RA-19-0144

February 19, 2020

Subject: Duke Energy Carolinas, LLC
Oconee Nuclear Station, Units 1, 2 and 3
Renewed Facility Operating Licenses Numbers DPR-38, DPR-47, and DPR-55
Docket Numbers 50-269, 50-270, and 50-287

License Amendment Request for Measurement Uncertainty Recapture Power Uprate

Figure 3.4.3-1 (page 1 of 1)
RCS Normal Operational Heatup Limitations
Applicable for the First 44.6 EFPY - Oconee Nuclear Station Unit 1

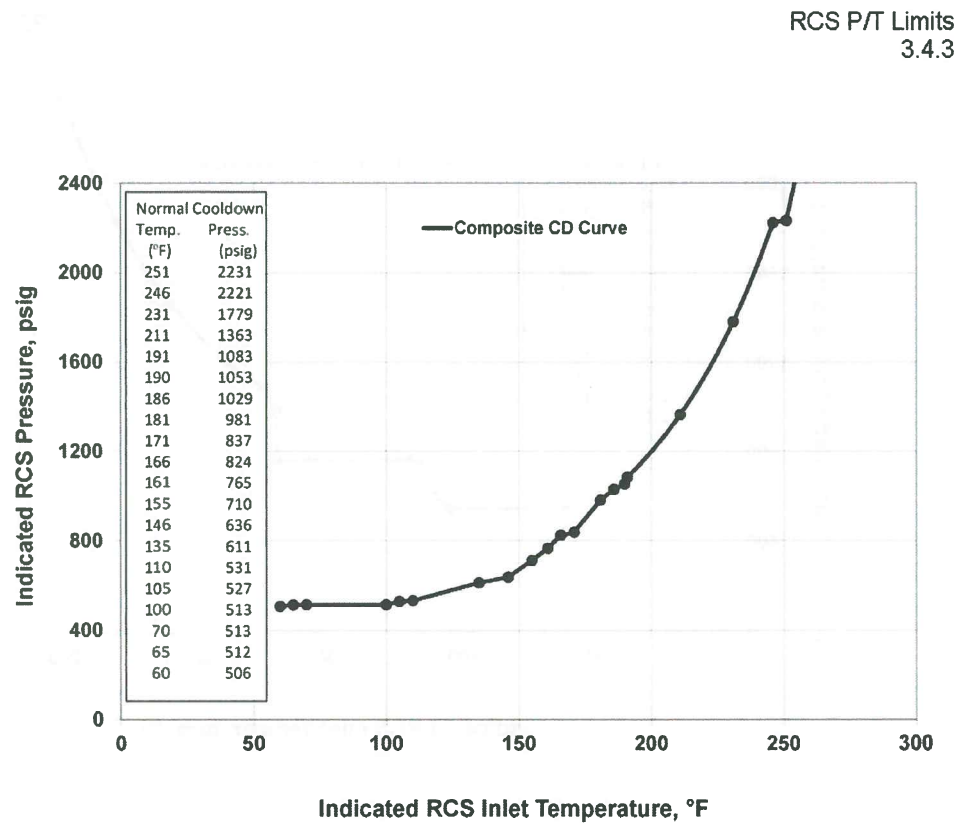
The Applicability for the RCS Heatup and Cooldown limit curves is revised to 44.6 Effective Full Power Years (EFPY) for Unit 1, to 45.3 EFPY for Unit 2, and to 43.8 EFPY for Unit 3 based on updated reactor vessel (RV) material evaluations discussed in Section IV.1.
